# INNER WEST COUNCIL

## DEVELOPMENT ASSESSMENT REPORT

| <b>Application No.</b>                            | D/2018/251  |
| <b>Address</b>                                    | Empire Hotel, 103A Parramatta Road, ANNANDALE NSW 2038  |

Figure 2: Gross floor area – existing vs proposed.

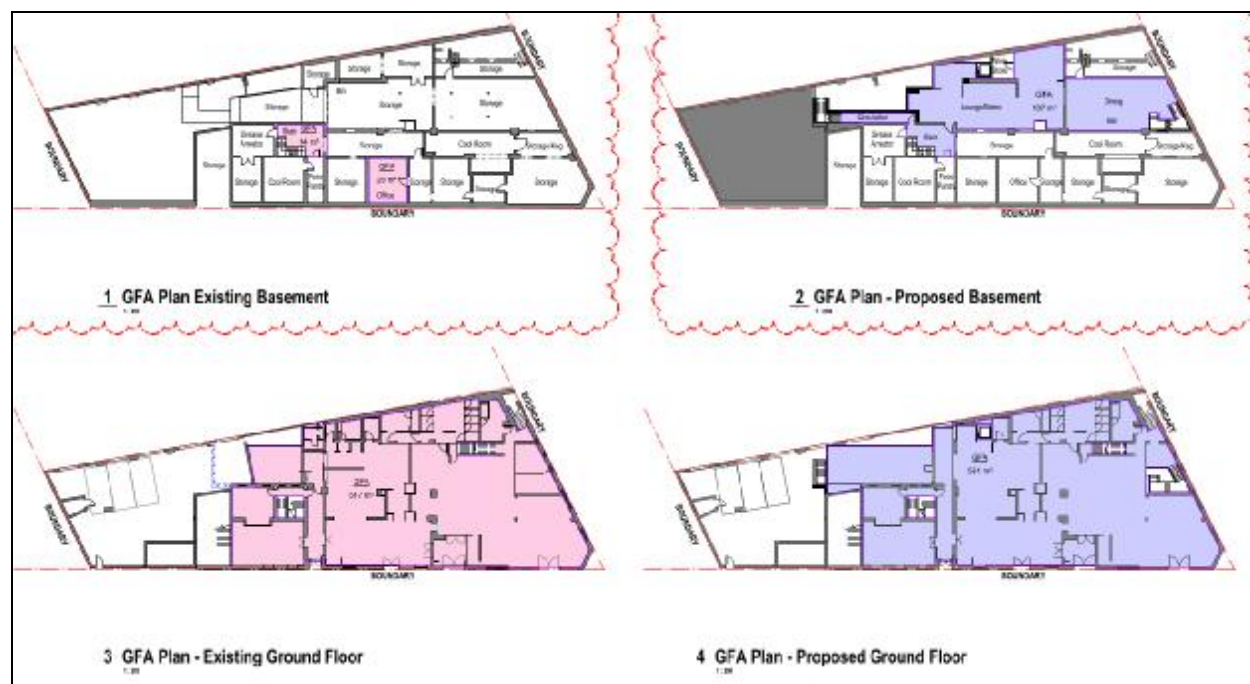
Comment: The proposal adds gross floor area primarily through the conversion of existing storage areas at basement level to commercial use as indicated in the diagram below.

Comment: The applicant has addressed the matters required under Clause 4.6 Exceptions to development standards, and it is considered to be well founded in this instance. The

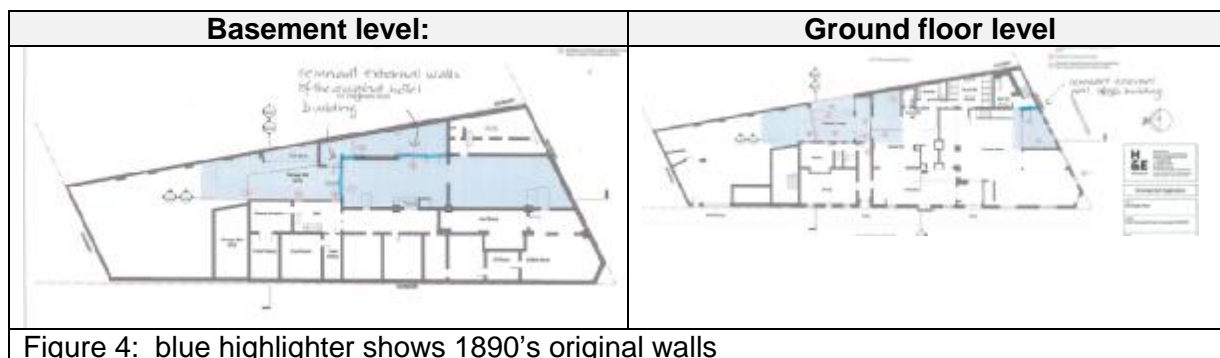
None of the proposed changes to the ground floor in the Gaming Lounge area impact on what survives of the 1890s building. The proposed demolition the original external wall of the hotel is not supported on heritage grounds.

While best heritage practice would retain the 1890's walls, these walls have long been internalised within the building, are not visible from any public place and would be able to be modified as complying development. For these reasons, the proposed partial demolition is considered acceptable in this instance.

Figure 5: Doors to be egress only after 10pm circled in red.

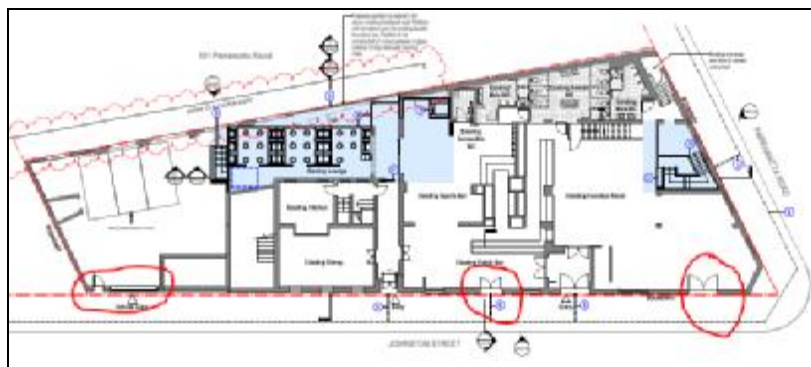
The submitted Plan of Management should be amended to comply with Council's requirements for Plans of Management for Non-low Impact Premises. To ensure compliance with the specific controls conditions will be imposed as follows:

1. Require the doors that do not contain air locks to be closed after 10 pm, other than to allow exit.
2. An external sign shall be erected on the Johnston Street frontage with a 24 hour contact number for management for the use of members of the public concerned about operation of the premises.
3. Update existing trading hours to be consistent with approved hours / website.
4. Ensure a copy of any noise complaints registered in log book are forwarded to Council.
